## **Accessibility Survey**

# City of Downey

## Dinwiddie Street - Old River School Road To Rio Hondo Drive

Date of Inspection 2/10/2017

## Change In Level West Of Old River School Road @ 33.948557700134, - 118.149611949921

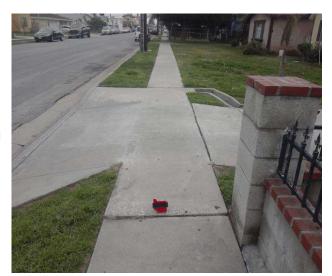
There is a change in elevation greater than recommended value.

On-Site Finding 0.75 inches

Ensure that the change in elevation not exceed a .5 beveled inch.

Recommendation Up to 0.50 inches

## Change In Level West Of Ryerson Avenue @ 33.951908480850, -118.155834674835

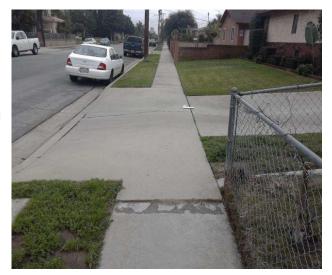
There is a change in elevation greater than recommended value.

**On-Site Finding** 0.62 inches

Ensure that the change in elevation not exceed a .5 beveled inch.

Recommendation Up to 0.50 inches

#### Driveway East Of Ryerson Avenue @ 33.948246199873, -118.148742914200

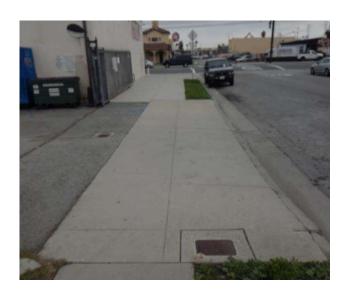
There are no detectable warnings where the pedestrian route crosses vehicular traffic.

**On-Site Finding** Not Found

Provide detectable warnings.

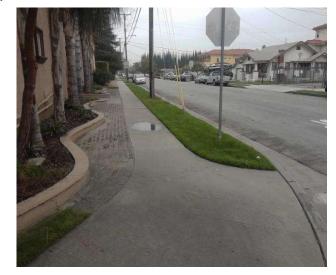
There is no 60X60 turn area at every 200 feet.

**On-Site Finding** Not Found

Provide a 60X60 turn every 200 feet on the sidewalk.
